Structural Review

Refer to Existing Plans and Exterior Elevations marked up with our site observations following this narrative, along with our preliminary chapter 34 evaluation information. Text in bold represents our recommended scope of work.

Exterior Elevation Notes: Emery Grover Building, Needham, MA

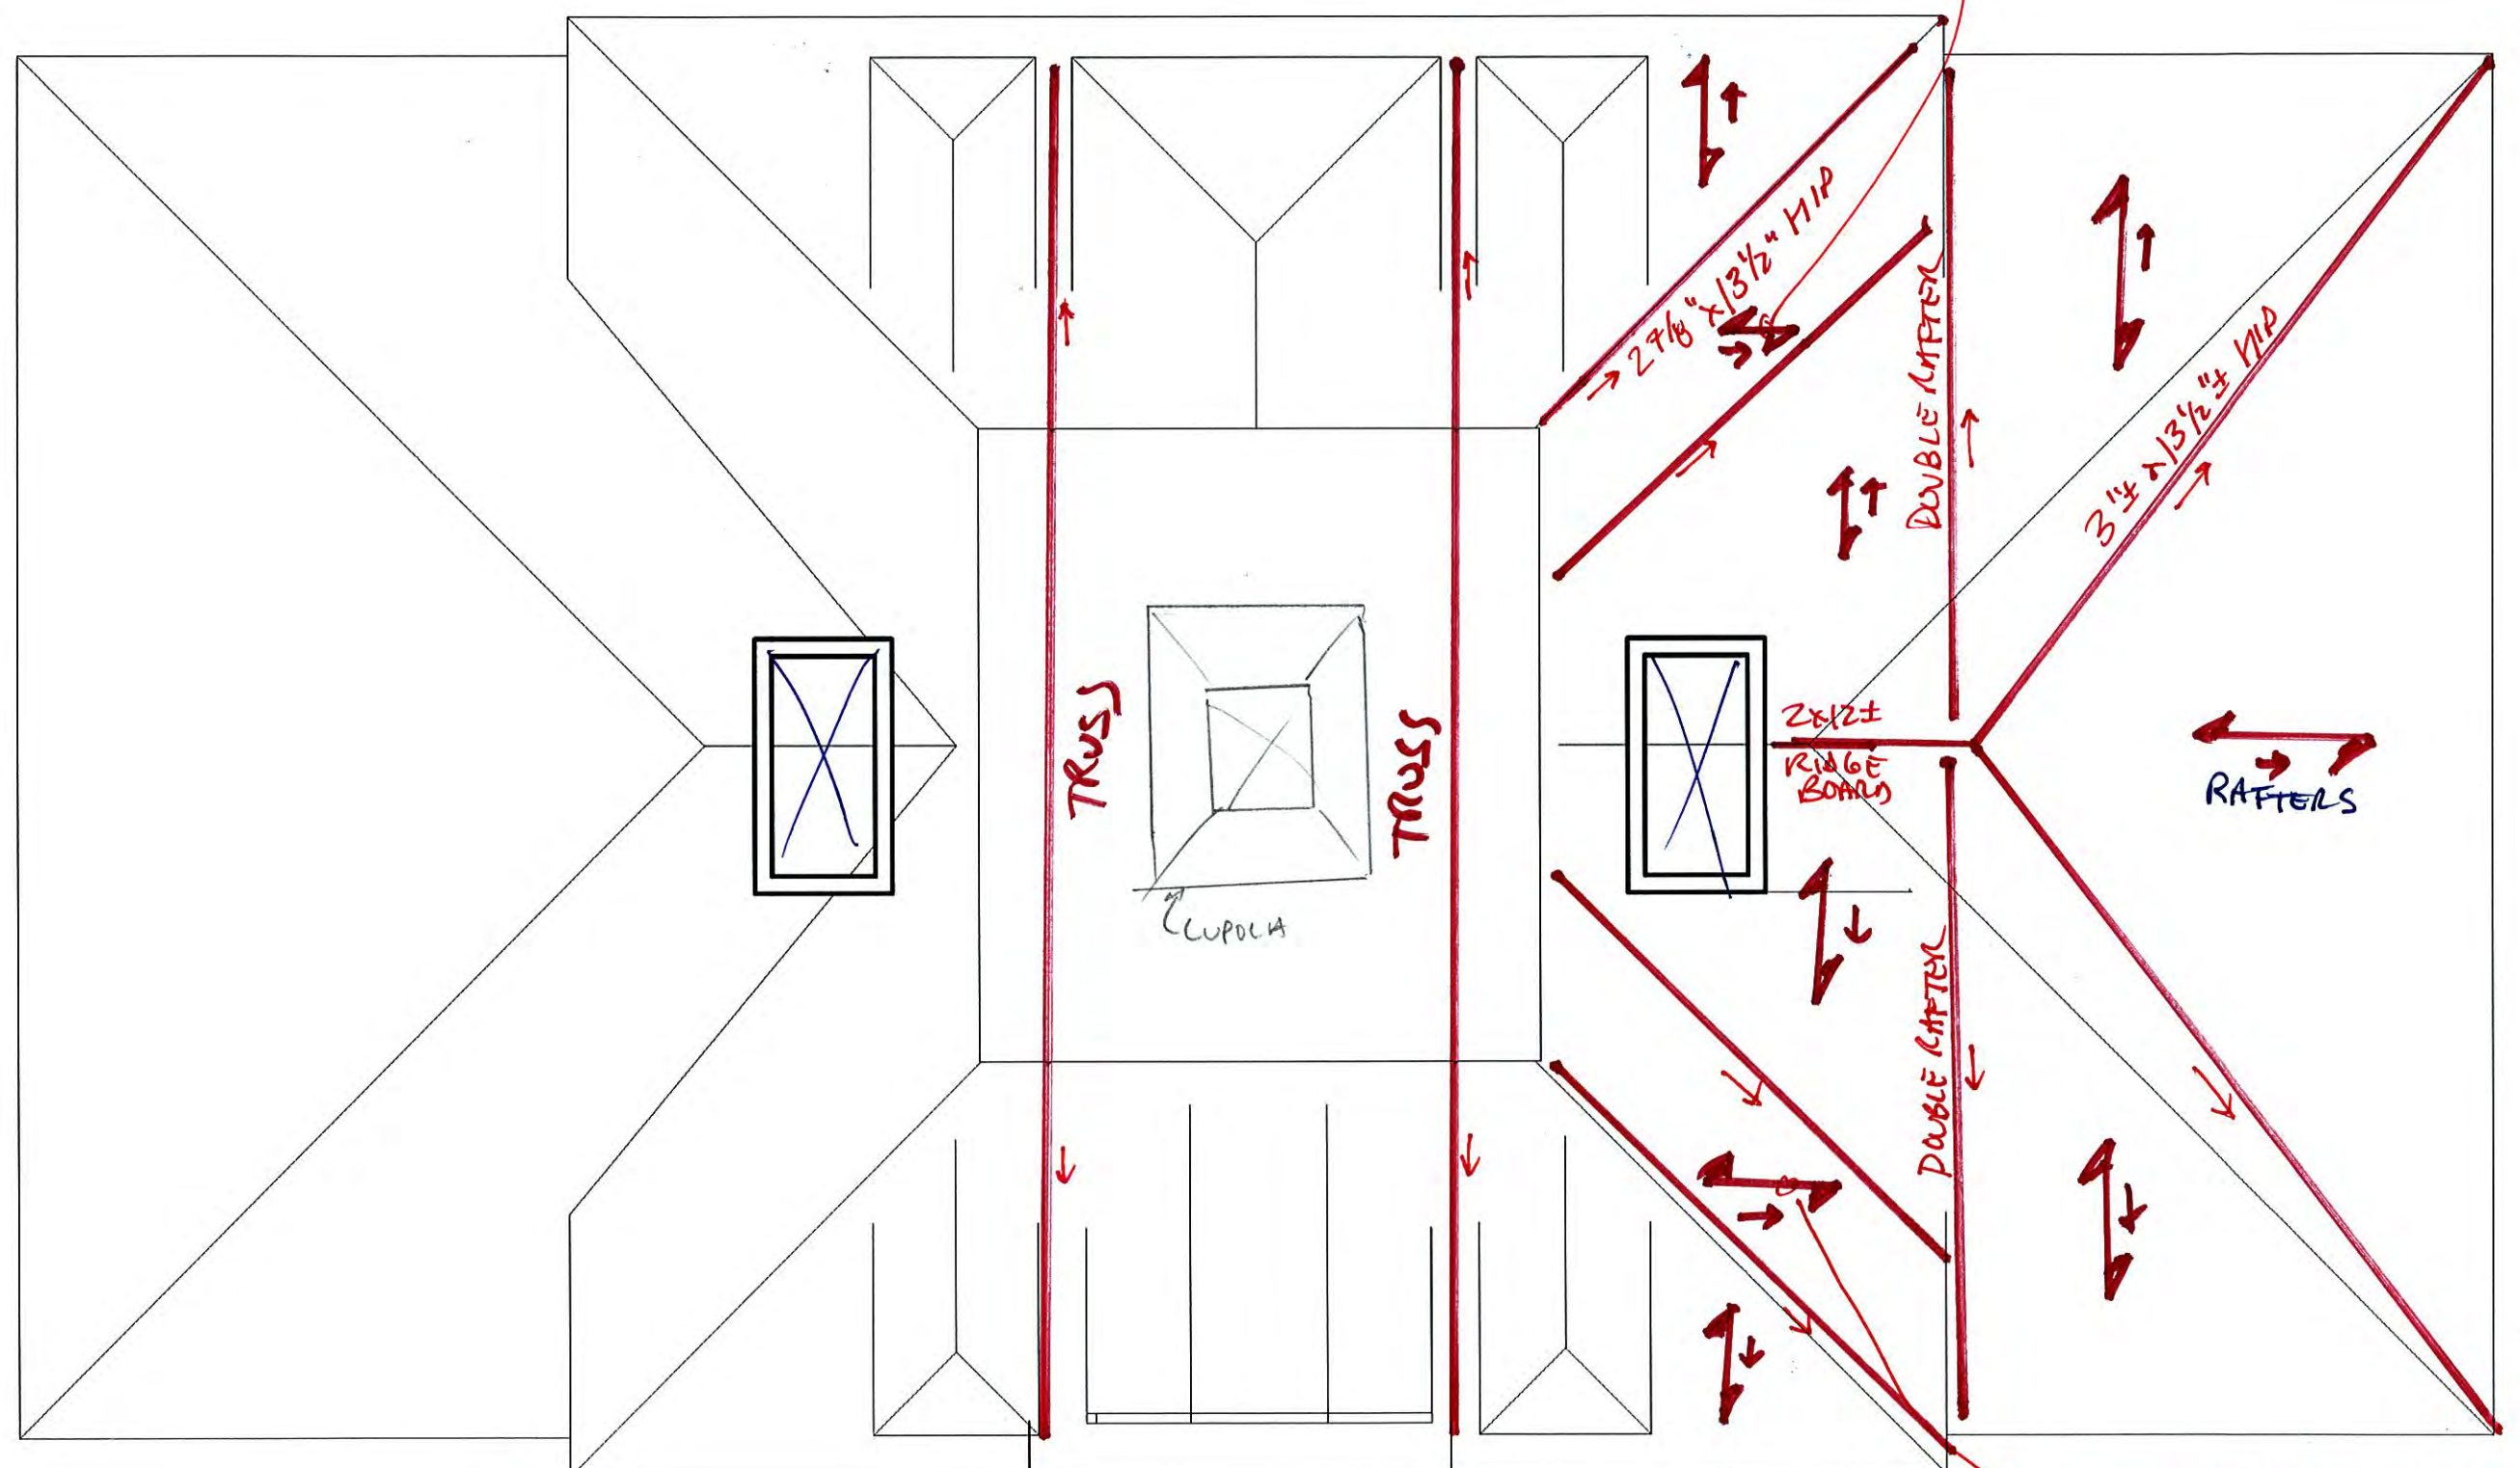
At the south portico, existing steel reinforcing of the 3 arches was observed. A previous engineer's report noted the need for temporary reinforcing of the arches. Our elevation markups note using similar reinforcing at the north

portico, which is exhibiting serious cracks in the arch. **If the steel reinforcing at the south portico was intended to be temporary, then a new reinforcing scheme will need to be developed for both porticos. Assume extensive brick re-setting and repointing at the north portico, along with temporary arch shoring and permanent tension rods at the spring of the arches at all arches in both porticos.**

EXISTING
ROOF PLAN
1/8" = 1'-0"±

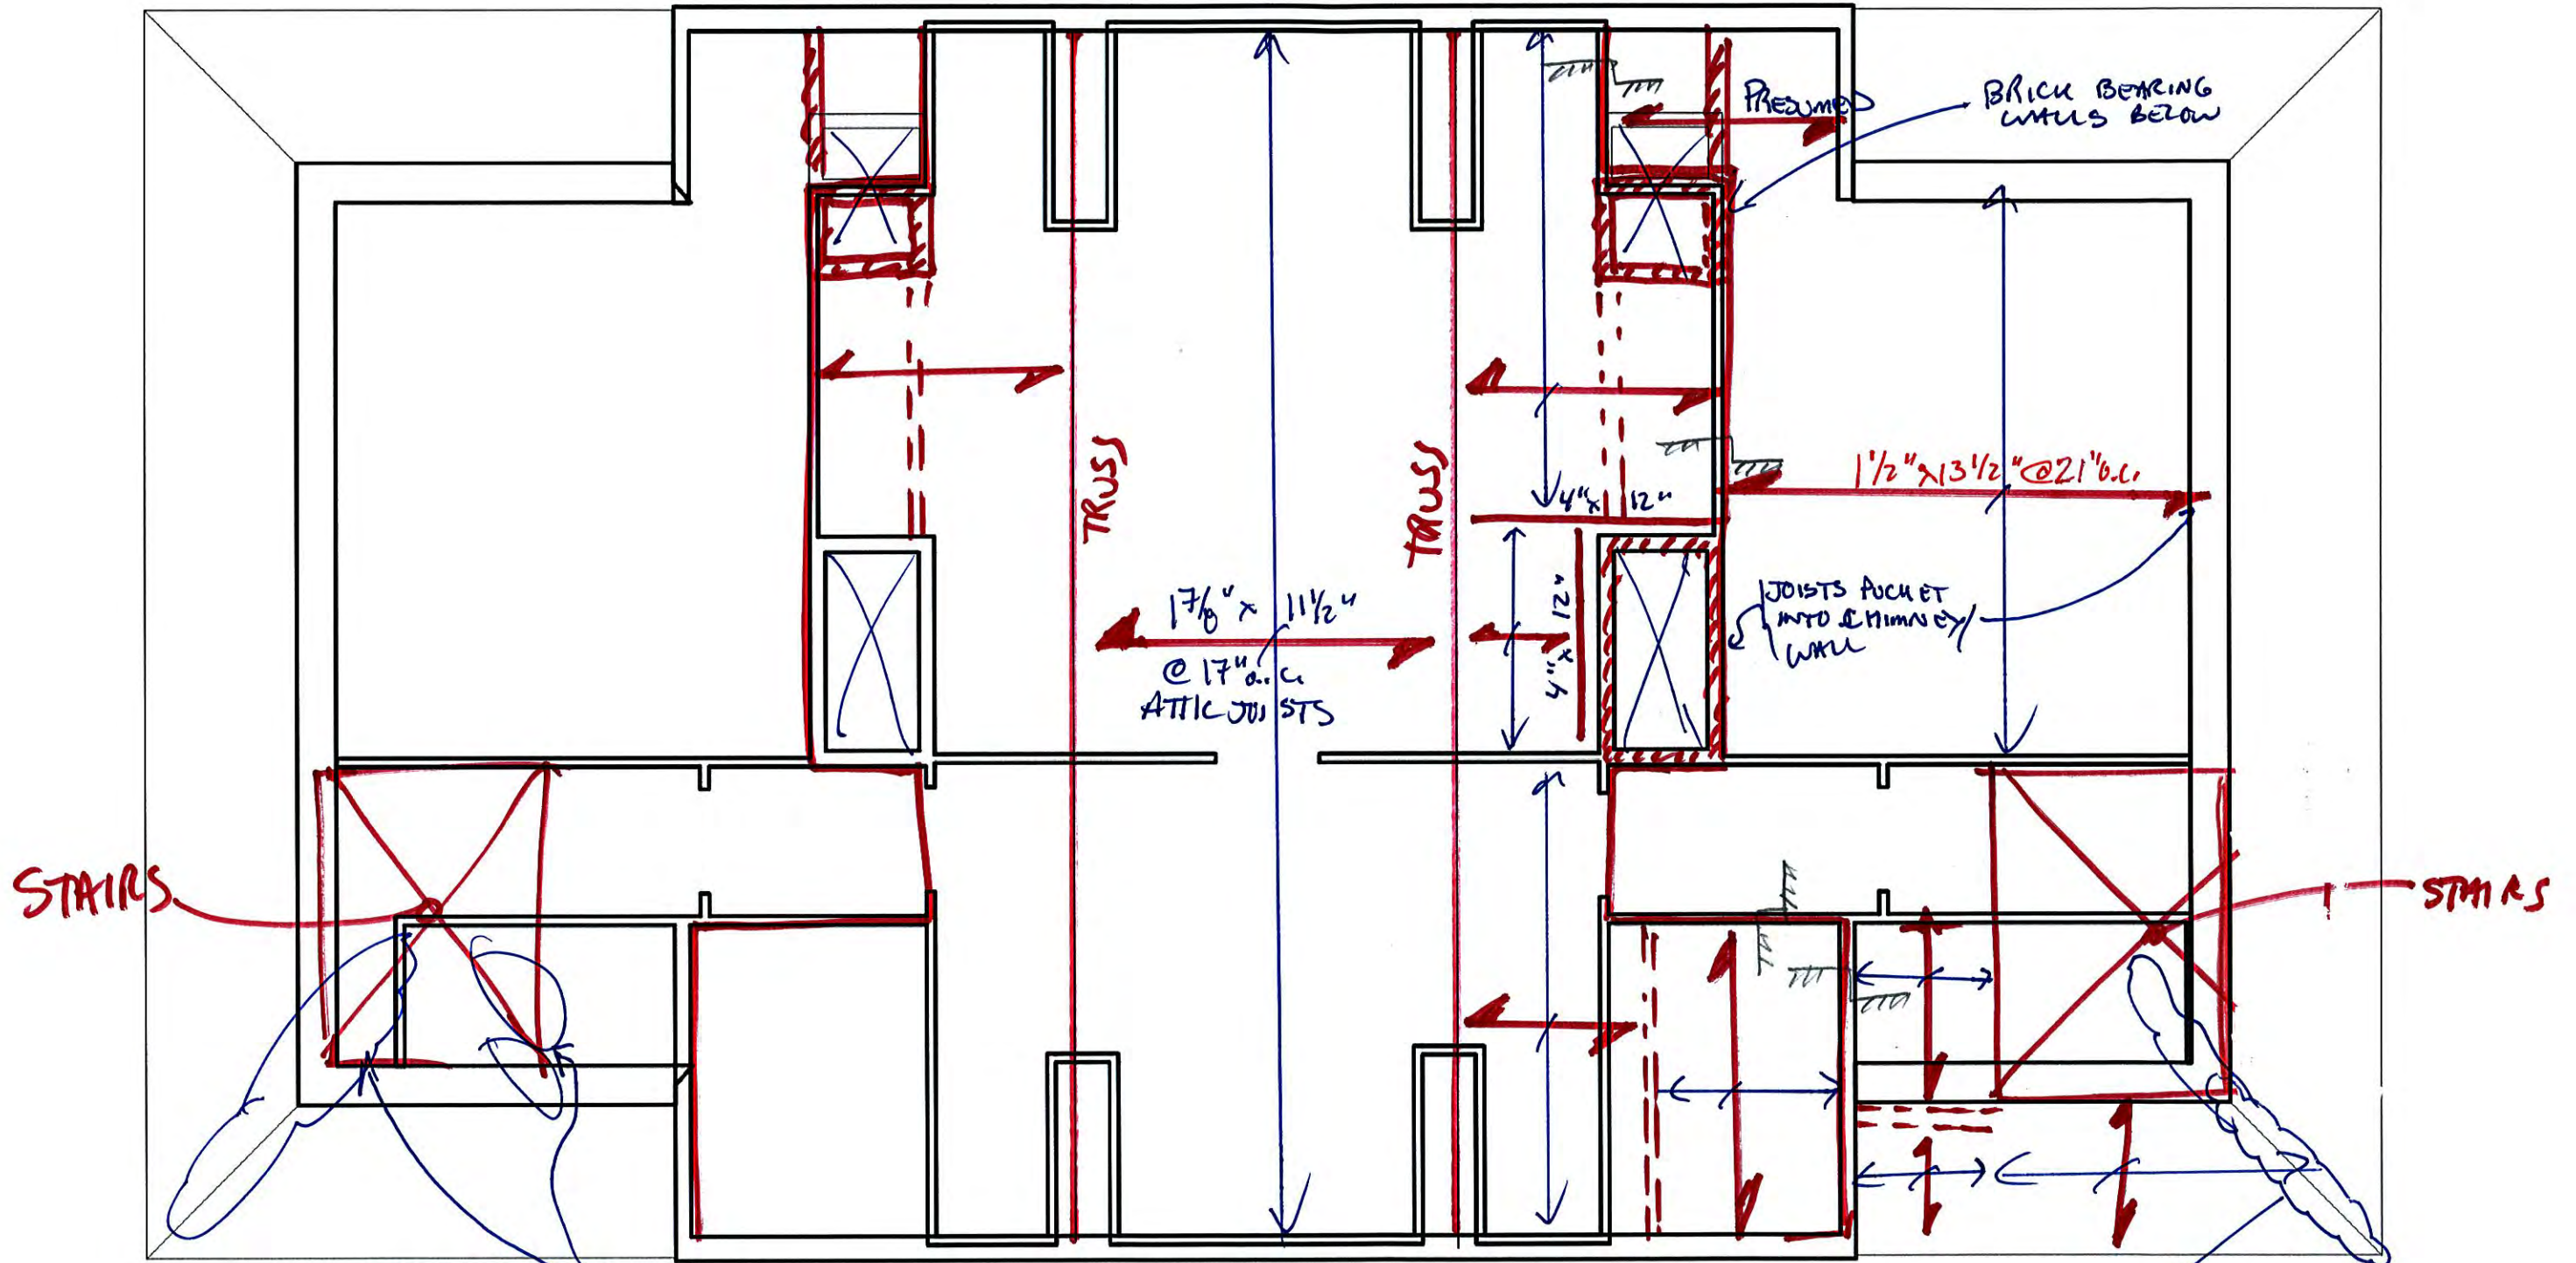
Not all attic framing was visible during Structures North's site visit. Snow guards were observed on the east and west sides of the building. It is assumed that the guards were not a part of original construction, and it is unknown whether the roof was evaluated or is capable of supporting the additional snow loads caused by snow guards. **The roof might need a full evaluation, and if found to be undersized, reinforcing and/or additional columns installed.**

1 3/4" x 1 1/2" @ 24" o.c.
